# RONALD T. JEPSON & ASSOCIATES

*Re: Peer Review of Water Resources Documents for Fairhaven Highlands*

SUBJECT: Wetland Calibration in the Fairhaven Highlands.

SUBJECT: Response to Adolfson's Peer Review of Water Resources Documents for Fairhaven Highlands

Figure 1 – Observed vs. Simulated stage data at Wetland CC

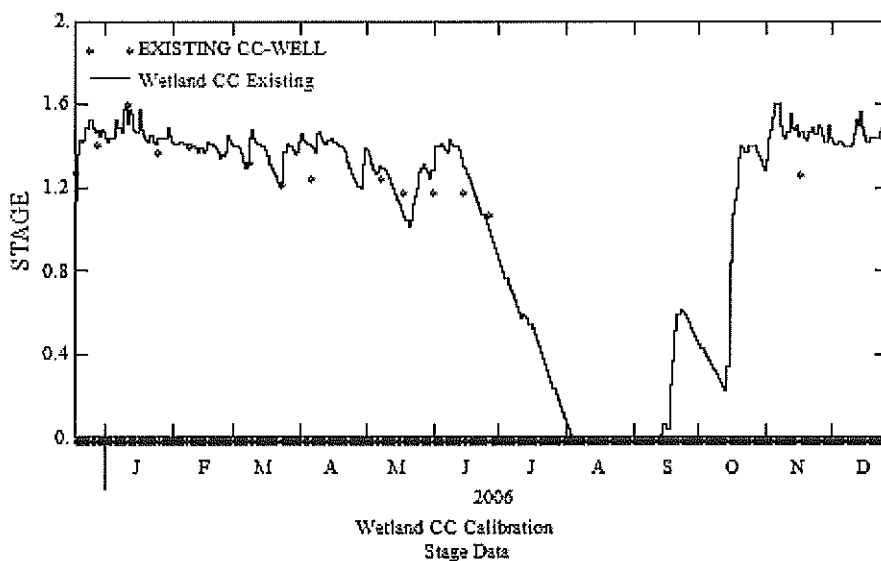
1. Comment on how or if the wetland monitoring data were used to support development of the modeled wetland hydroperiod analysis.

For the most part the simulated stage data closely matches the observed stage data. This indicates that the modeled representation of the wetlands closely simulates the existing hydroperiod for each wetland. This validates the use of the model to estimate impacts to the wetland hydroperiods based on the proposed development. It should be acknowledged that the period of record is only about one year and the data is only collected on bi-weekly basis. Additional data may enhance the quality of the calibration but is unlikely to alter the wetland behavior significantly.
